**Summary of Stream Restoration Activities at Sites 14 and 15 in the
Kitwanga River South Sub-Basin to March, 1999**

Prepared for the
Gitsegukla Band Council

March 31, 1999

Activity Number 12395 - SR - Restoration Prescription Implementation for Prescription Sites 14 and 15 Kitwanga River South Sub-Basin

Figure 2. Construction drawing for Site 14, Kitwanga River.

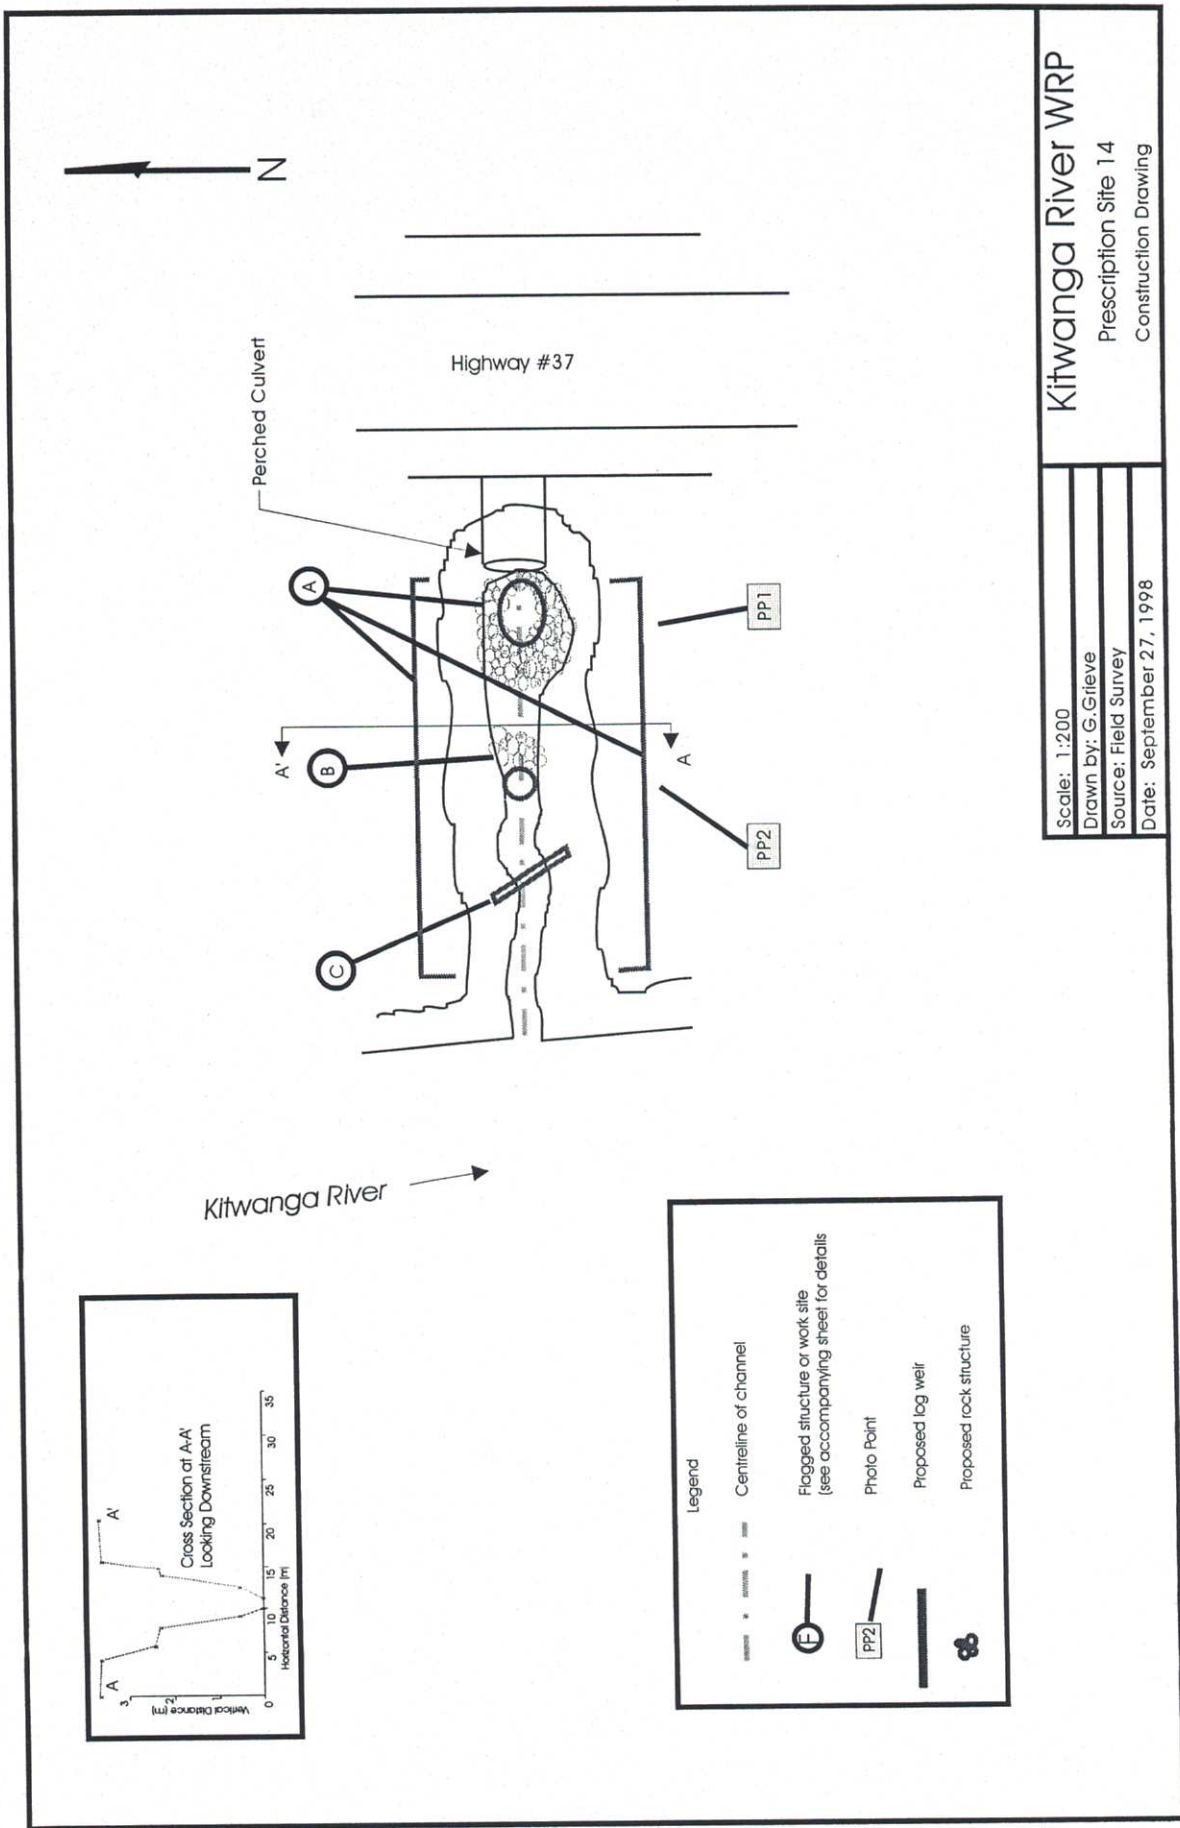
Site 14 - Our first concern with this project is in regard to the pull back of the banks. This activity was not initially prescribed nor approved for work at the site. The pull back that was undertaken is of concern given its proximity to the highway and, specifically, within the road right of way. Was the Ministry of Highways consulted regarding this change?

Prescription implementation was to be as per the BioLith's 1997-98 report as delineated within the Water Act Regulations Section 9 Letter of Notification. Such prescription alteration and associated pull back to the suggested angle of repose must have been submitted for consideration by the Technical Monitor, or designate, prior to any work commencing at this site. Adherence with Section 4.1 of the Schedule "A" for Site 14 is paramount. Deviation from the prescription must follow the process as outlined within the Standard Agreement and the respective Schedule(s). Regardless of holding a Letter of Notification for specific in stream "timing windows" for work to be undertaken, the prescription alteration must be submitted for review and incorporation into a revised Letter of Notification. Clearly work should not have commenced without fulfilling all these requirements and, as such, violates Section 4.2 of the Schedule "A" and that is unacceptable to the Ministry.

Construction of the step pool system at Site 14 does not appear to be adequate to meet the goal of better facilitating fish access through the culvert. We are also concerned about the size and orientation of the materials used to construct the weirs (their long term stability is questionable). Close monitoring of this site at various flow levels, and associated modifications, will be required to fulfil the goal of creating long term fish access through the culvert.

Finally, the loss of the riparian low shrub and herb cover at Site 14 associated with the work undertaken last fall has increased surface erosion and will continue to deliver sediment into the Kitwanga River until inevitable revegetation takes place. On that note, the grass seeding that was planted seemed sporadic. In addition this surface erosion will not be mitigated by the silt fence given that its' installation was done incorrectly. This will require correction if not already done so. Again monitoring of this aspect of the project will be conducted this Spring after snowmelt.

Given the problems outlined above, no quality certificate will be issued until the site is monitored and appropriate changes are completed this Spring.

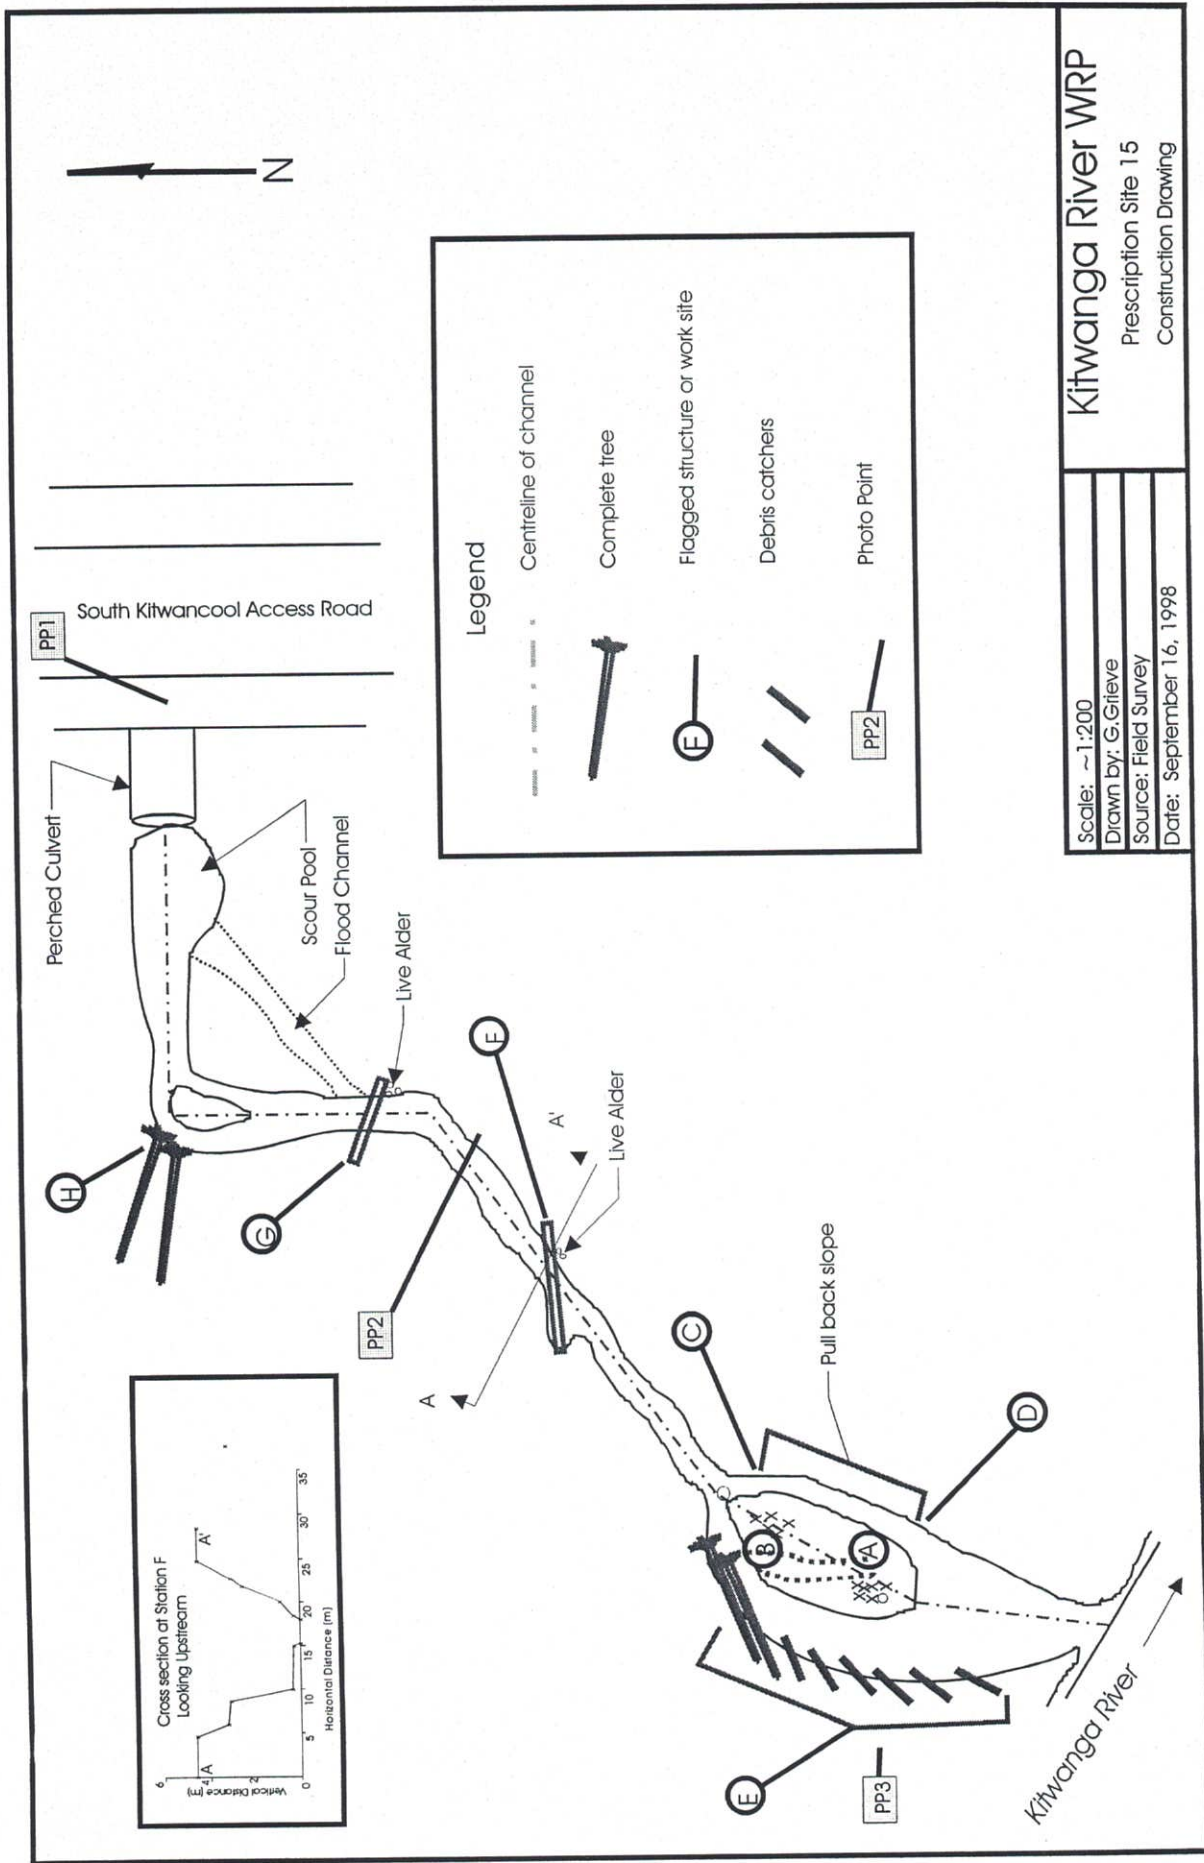
With respect to Site 15, they suggested that, although the LWD was of high quality, branches and tops should be left attached. They further suggested that the LWD be anchored. Concerns were expressed over the stability of the debris catchers, possible end scouring around a channel spanning piece of LWD, riparian area degradation by machine use and the channel excavation.

Site 15 - The Recipient provided a good source of Large Woody Debris (LWD) by species and by size. Root wad presence was good but it would be advantageous, in future, to leave branches and tops attached to the LWD pieces to increase their stability. If the objective of using rope to tie the structures together was to increase their stability, then we suggest rock anchoring would help better achieve your objective.

It is recommended that, if significant movement is observed during future monitoring, the LWD installed at Site 15 should be anchored to imported boulders >65 cm in their b axis, using steel cable >1.5 cm in diameter epoxied into 15 cm deep holes drilled into the rock using the Hilti Epoxy system. Such boulders may be available along the west Kitwancool Lake FSR.
